**Bureau of Environmental Health**

RECEIPT DATE: 8/2/18 **ONSITE SEWAGE DISPOSAL SYSTEM**P 563970APPROVAL DATE: 9/17/18 SEC **PERMIT: CONSTRUCTION**

PROPERTY ADDRESS: 1025 Thunderbird DriveSUBDIVISION: Fairlane FarmsLOT: 31 TAX ID: _____CONTRACTOR: South Carroll BackhoeEMAIL: scbackhoe@comcast.comCONTRACTOR ADDRESS: 4410 Salem Bottom Road, Westminster, MD 21157PHONE: 410-596-3618PROPERTY OWNER: NV Homes

SEPTIC SYSTEM
INSTALLATION SITE PLAN
LOT 31
1025 THUNDERBIRD DRIVE
FAIRLANE FARMS
PHASE TWO

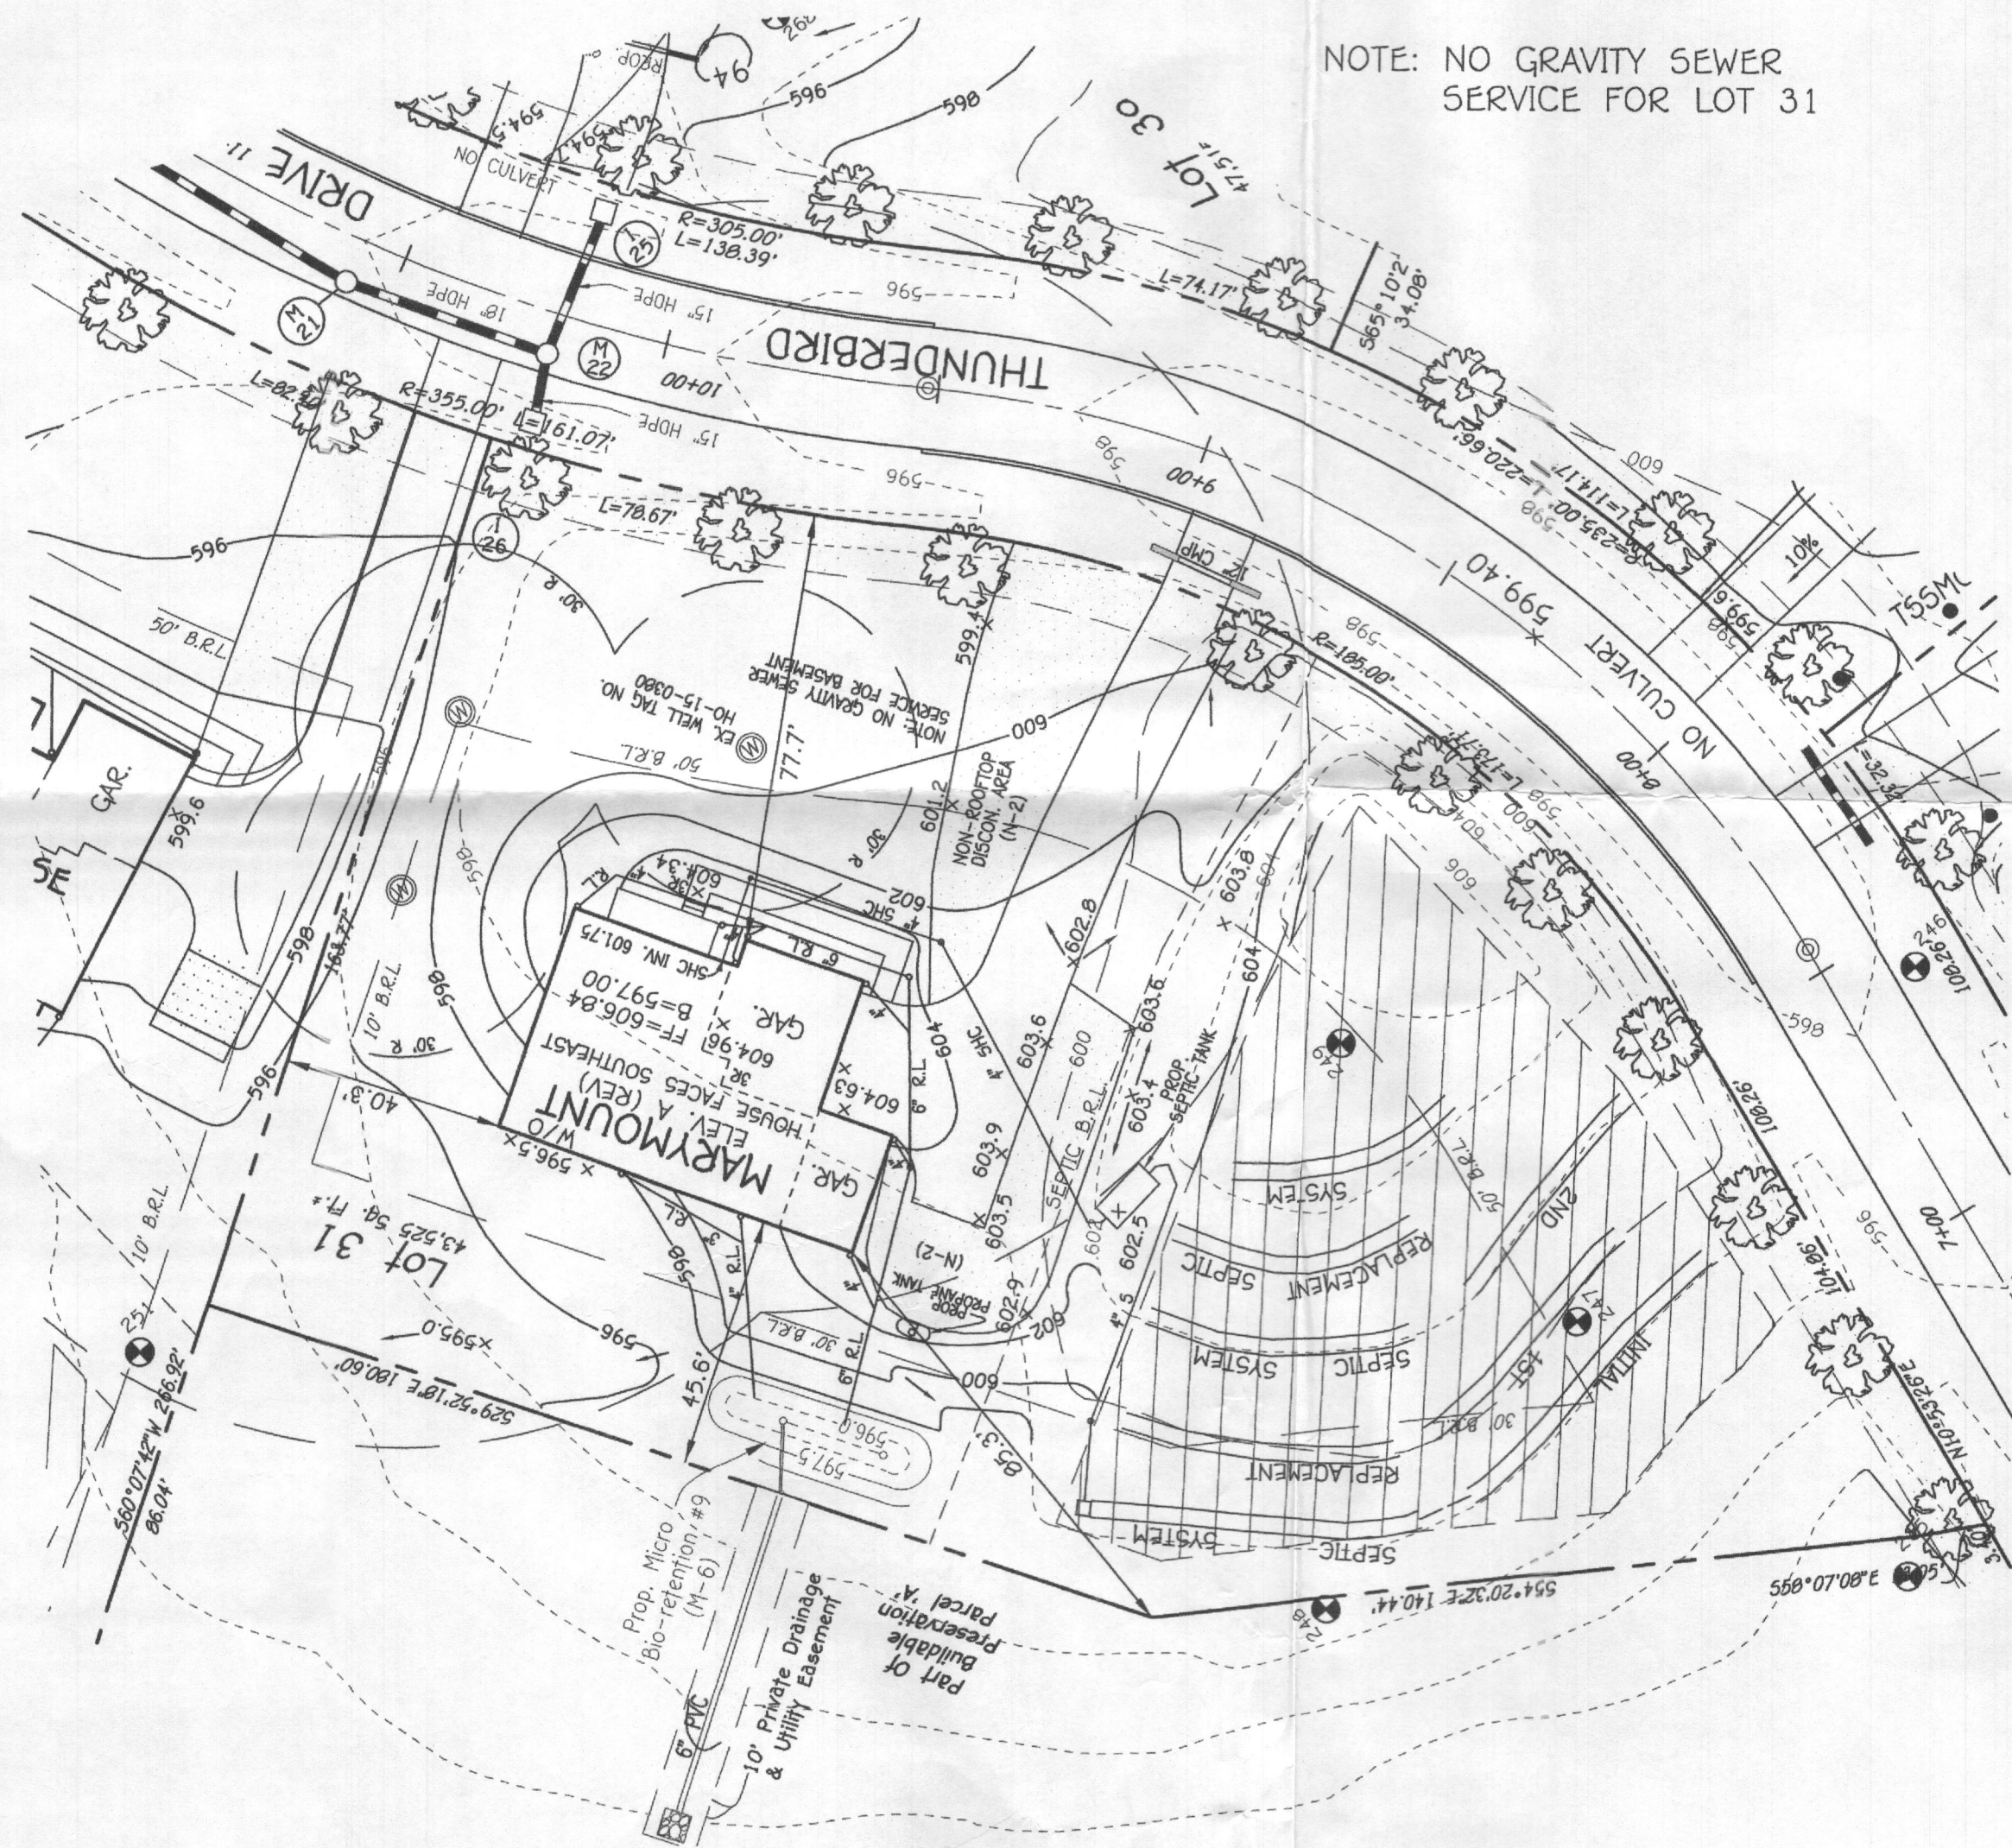
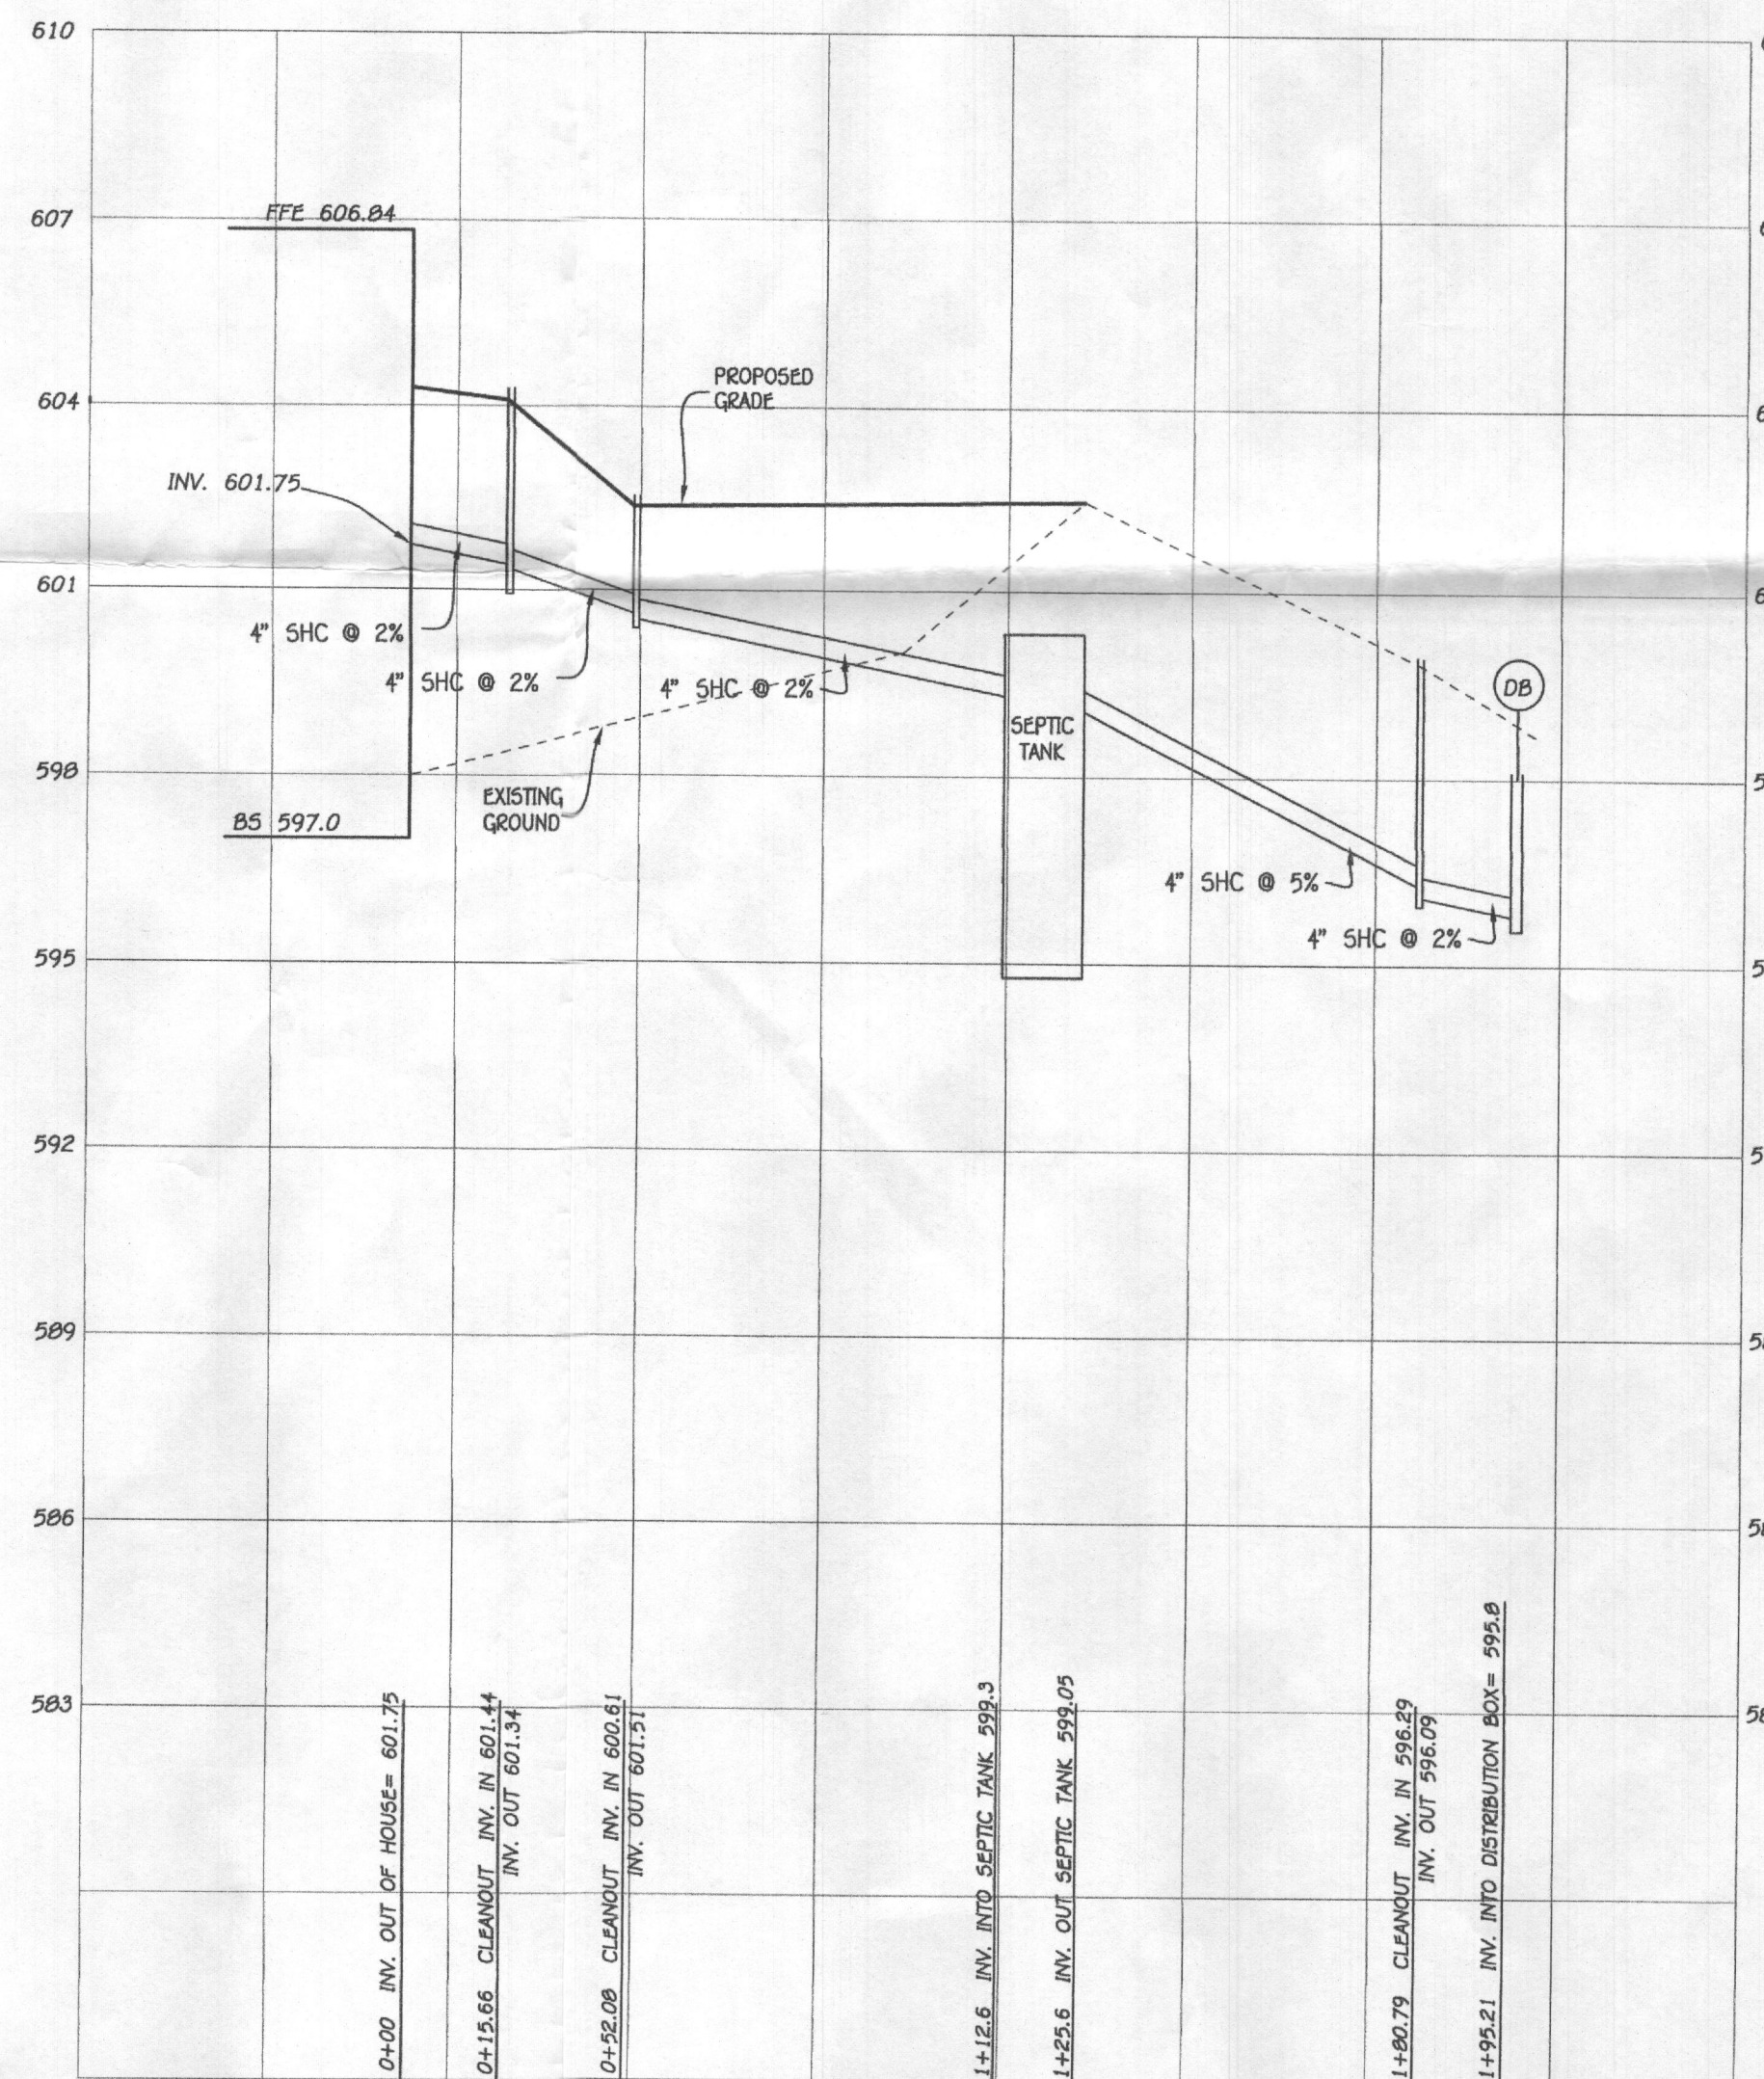
So if I'm understanding you correctly, the initial system will be at the bottom (lowest elevation) of the septic area, and the trench sizing will use the spec's for the 2nd replacement system (since that pertains to the lowest part of the septic area), correct?

Lot 31 is one of those lots that will work as a 1st floor gravity sewer system (a ejector for the basement sewer) if the initial septic trench starts as shown on the attached drawing. To force us to place the initial trench up higher will force the need for a whole house pump system and that is a big negative for the homebuyer of course. We easily fit 3 systems in the SDA with this layout, and hope the Health Dept. agrees that this will be acceptable. The initial trench lengths are 3 @ 43.8 ft. The 2nd system trench lengths are 3 @ 49.6 ft. And the 3rd system trenches are 2 @ 60.1 ft. in length. Please let me know if this will be acceptable, so we can finalize the plan and let the builder and homebuyer know please.

Yes. Make sure the trench layout utilizes the lowest contour in an efficient manner. I would leave the tank where it is so that the homeowner can get gravity systems for as long as possible with future repairs.

Our general policy is to place the first system in the upper contour of the SDA. We occasionally make exceptions to this rule, but when we do, the policy is to install a system on the lowest contour, so that we maximize our area moving forward, just in the opposite direction. Starting the first system somewhere in the middle is not efficient use of the area. In this case, the lower part of the area does not have worse soils, so I'll allow a design showing the first system on the lowest contour and the future replacements can work their way up the hill.
